## Bernera Rd Upgrade, REF Feedback

### Project Reference: BER Ref-1/2024

Thank you for the opportunity to comment on the plan to upgrade Bernera Rd between Yarrawa St and Kurrajong Rd (*The Plan*).<sup>[1]</sup>

Marked-up Google Satellite View image<sup>[3]</sup> of the apparent intended AT route across the M7 interchange.

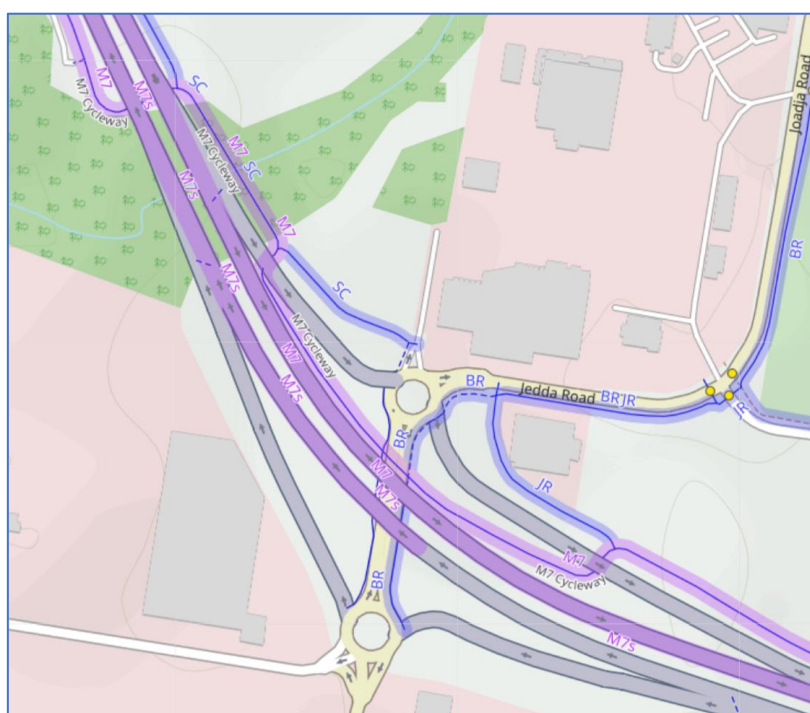
We are concerned about the apparent intended 300m AT route through the M7 interchange, which runs between the northern end of the proposed Bernera Rd SUP at Yarrawa St intersection and the Jedda Rd eastern M7 path access ramp. This is covered by the grey and blue lines on the map overlay to the right.

This route is through a major interchange between the M7 entrance and exit ramps and Bernera Rd, Jedda Rd and Yarrawa St. It consists of two roundabouts (referred to below as the northern and southern roundabouts), with existing SUPs on both sides of Bernera Rd between the northern roundabout and the M7 entrance and exit ramps on the southern roundabout. The diagram from *The Plan* on the following page indicates that the path on the eastern side of Bernera Rd is slated to be used. These existing paths attract very little use at present as they don't really lead anywhere. The proposed Bernera Rd SUP has the potential to change that.

Part of Sheet RD-0101 Sheet 3<sup>[4]</sup> showing the proposed SUP on the western side of Bernera Rd, crossing of Bernera Rd just south of the southern roundabout, and path to the M7 northbound exit ramp. The image is rotated around 90 degrees to the right from the actual layout.

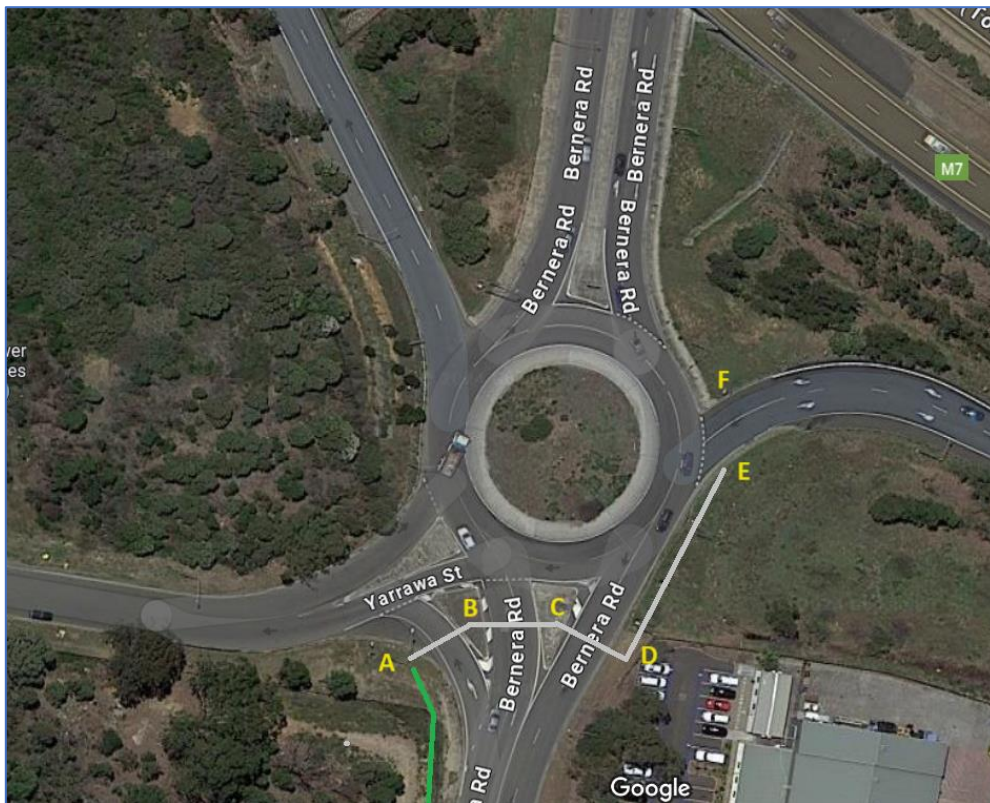
In the 'Our Focus' section of the 'Active Transport Strategy'<sup>[5]</sup> document, Transport for NSW make two references to SUPs being accessible to all.

***We don't believe the apparent intended route fits these definitions.***

Our concerns centre around the multiple road/carriageway crossings that will be required for AT users traversing this route. Apart from being a safety concern, we believe it will act as disincentive for many AT users who would potentially use this route segment as part of their longer rides or commutes.

Marked-up Google Satellite View image<sup>[3]</sup> of the southern roundabout.

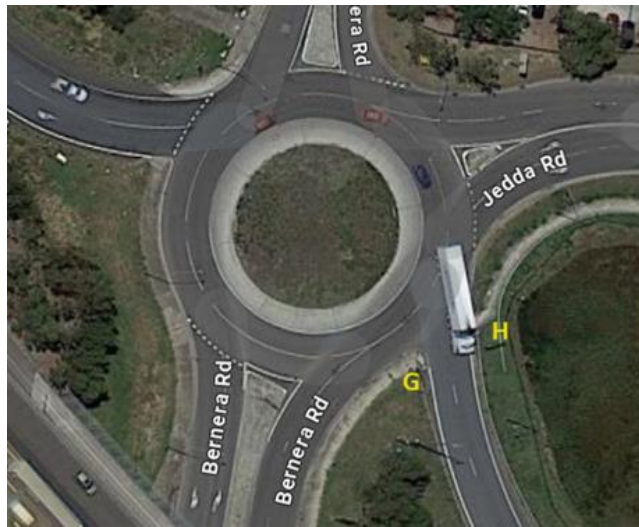
### **B-A crossing:**

It is difficult to determine if vehicles with left blinkers on are turning left from Bernera Rd into Yarrawa St or proceeding into the roundabout and turning left onto the M7 northbound entrance.

### **A-B crossing:**

Crossing A-B would likely be more challenging when there's moderate amounts of traffic around as users would need to turn around to look almost behind for approaching traffic.

### **B-C Crossing:**

Crossing dual lanes of traffic travelling north on Bernera Rd. As with the above point, vehicles with left indicators on could be turning left onto Yarrawa St before the crossing or coming through the crossing and turning left into the roundabout.

**C-D crossing:**

Crossing dual lanes of traffic coming out of the roundabout and heading south on Bernera Rd. Some vehicles turning left out of the M7 exit are travelling at a reasonable speed.

**D-C crossing:**

Difficult to see vehicles exiting from the M7.

**E-F Crossing:**

Crossing dual exit lanes of the M7 northbound. AT users don't have a clear line of sight for oncoming vehicles (particularly those in the left lane) due to the curve in the exit road and the vegetation. Vehicles are slowing down from (up to) 100 to 60 kmph.

**F-E Crossing:**

A little easier to see oncoming traffic than if crossing in the other direction – but still not ideal.

Figure 5.6 for multilane roundabouts from Austroads Guide to Road Design Part 4B – Roundabouts<sup>[9]</sup>

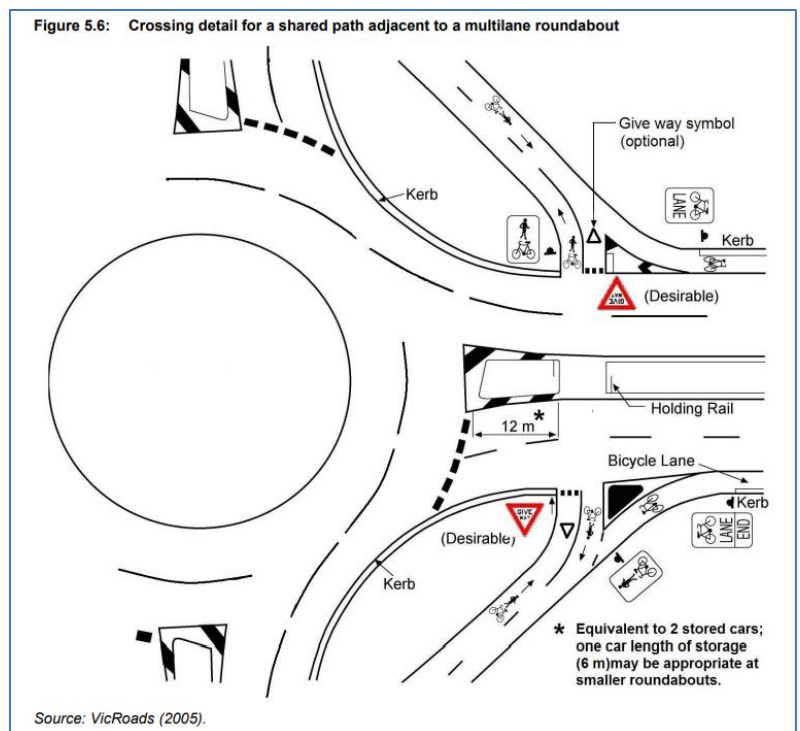
Neither the **E-F** nor **G-H** crossings have the 12 metres setback from the roundabout for SUP crossings at multilane roundabouts recommended in Austroads Guide to Road Design – Part 4B – Roundabouts.

The setback for crossing **C-D** appears to be a little under 10m.

Marked-up Google Satellite View image<sup>[3]</sup> showing the current SUPs around the interchange, Proposed Bernera Rd path and road crossing, and 8 alternative suggestions.

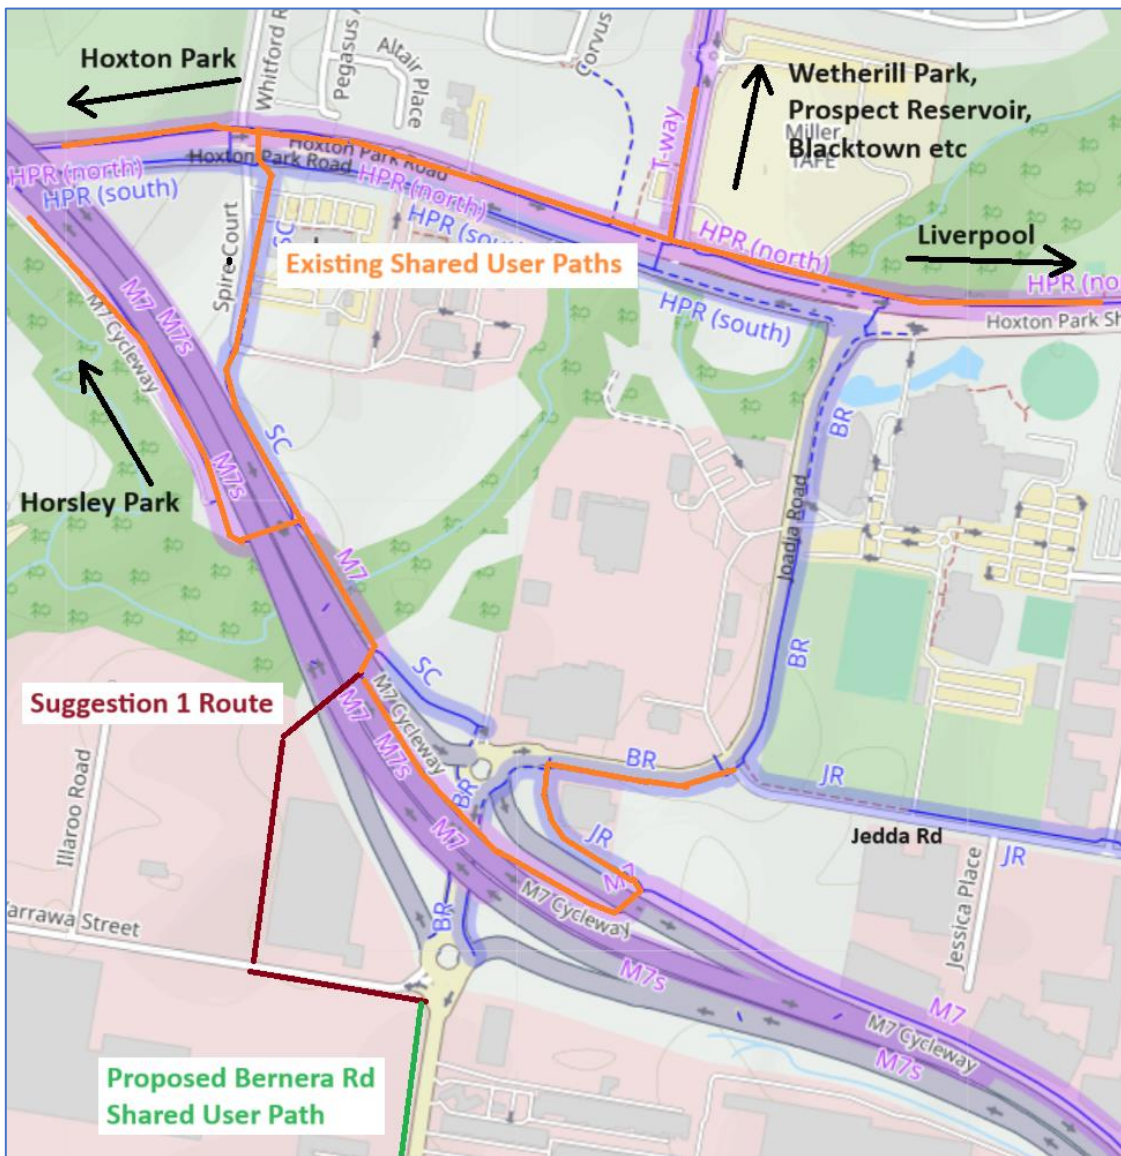
**Suggestion 1** is by far the best from a safety perspective for AT users as it removes all the above hazardous crossings. The only road crossing is of Yarrawa St, which doesn't carry a huge amount of traffic. If achievable, it would be a great route for those transiting between the proposed section of the Bernera Rd SUP and the M7 path north of Bernera Rd. As shown below, we believe it would also provide workable solutions for those transiting in other directions.

**Suggestion 2** replaces part of the Suggestion 1 route and would only be used if the above corridor through the substation land was not available. The route would consist of a shared path alongside Illaroo Rd and an extension to the Suggestion 1 path along Yarrowa St. This route would be longer and less desirable than the full Suggestion 1 route.

**Suggestion 3** is a way of avoiding the G-H crossing of the M7 south-bound entry. AT users would still need to use the E-F crossing and if Suggestion 4 is not implemented the A-B-C-D crossings as well.

**Suggestion 4** is constructing the shared path between Yarrowa St roundabout and Yato Rd/Yarrunga St intersection along the eastern side of Bernera Rd, then crossing to the western side with the lights. This would mean the crossing A-B-C-D is not required. There are currently more driveways (including a service station) on the eastern side which is not ideal. There may be other design reasons why the western side of Bernera Rd is preferable for the SUP.

**Suggestion 5** is to make the crossing of the M7 southbound entrance ramp a short distance along the ramp from the corner. The issue of going too far along is that vehicles will be traveling faster as they accelerate to join the motorway.

**Suggestion 6** is to take the crossing of the M7 northbound exit ramp up to the bend in the road so AT users have a clearer view of oncoming traffic. One disadvantage with this approach is that vehicles will be travelling faster as they decelerate coming off the motorway towards the roundabout.

**Suggestion 7** is another alternative to part of Suggestion 1 and runs between the complex at 5 Yarrowa St and the M7 northbound on-ramp. There is currently a reasonably sized drainage channel along at least part of this corridor which would likely need to be enclosed if this corridor were to be used. This route would be preferable to Suggestion 2.

**Suggestion 8** is along the northern side of Jemma Rd from the signalised intersection with Joadja Rd to Bernera Rd. It could be used for AT users coming from Joadja Rd and the T-way to access Suggestion 1 (via the M7 path on-ramp). There would still be the crossing of Bernera Rd north of the northern roundabout, but this section of road is a dead-end and doesn't carry a lot of traffic. Part of the northern verge of Jemma Rd is quite narrow, so we wouldn't be surprised if this suggestion is ruled out at least on those grounds.

Suggestions 3, 4, 5, 6 & 8 are not complete solutions in and of themselves. A combination of several of them would be required to increase AT user safety – and then it would be debatable by how much.

If able to be built, Suggestion 1 (with possible Suggestion 2 or Suggestion 7 variations) is by far the best outcome for both AT users and vehicles using this interchange. We believe it is the only presented option that:

**We urge Council to seek funding to investigate and potentially build a safer route for AT users along the lines of Suggestion 1. Preferably we'd like to see a solution in place by the time the full Bernera SUP is opened to users.**
